REN103/REN116

Replaced by

REN172

RENAULT:

REN172 - New design

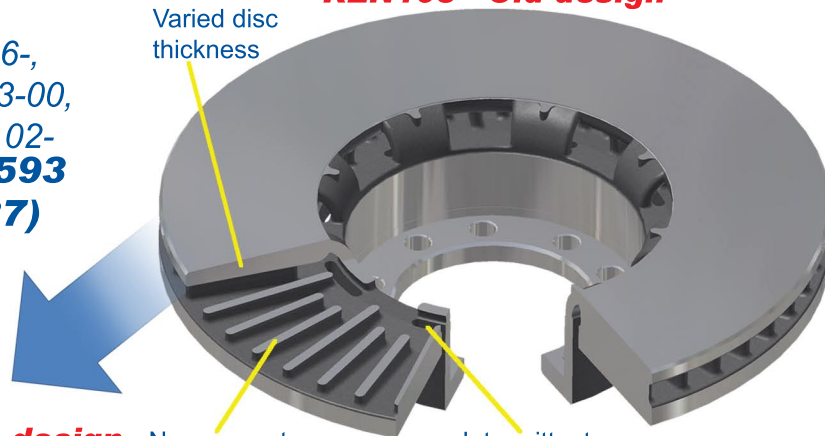
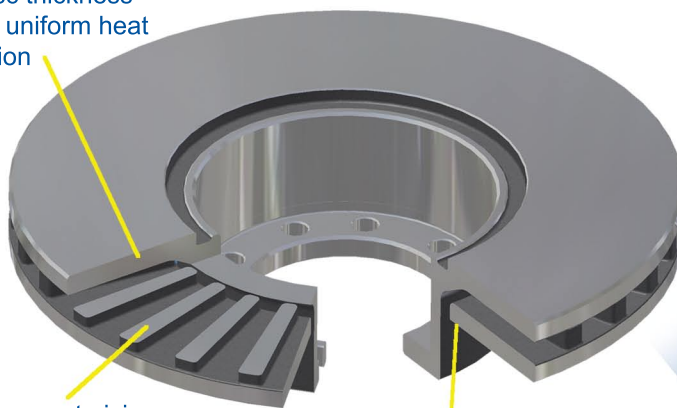
REN103 - Old design

REN116 - Intermediate design

Even disc thickness
creating uniform heat
distribution

Narrow vent

Intermittent
vent gaps

Thicker vent giving
added strength making
it less prone to warping

Increased vent gap, across
whole diameter of disc, thus
creating greater airflow

**This new design
improves the airflow
and heat distribution,
making the disc less
likely to crack under
severe conditions**

New "DIAMOND" shaped
pillar vent to substantially
increase airflow

Evenly distributed vents giving greater
support to the braking surface,
reducing the risk of high spots
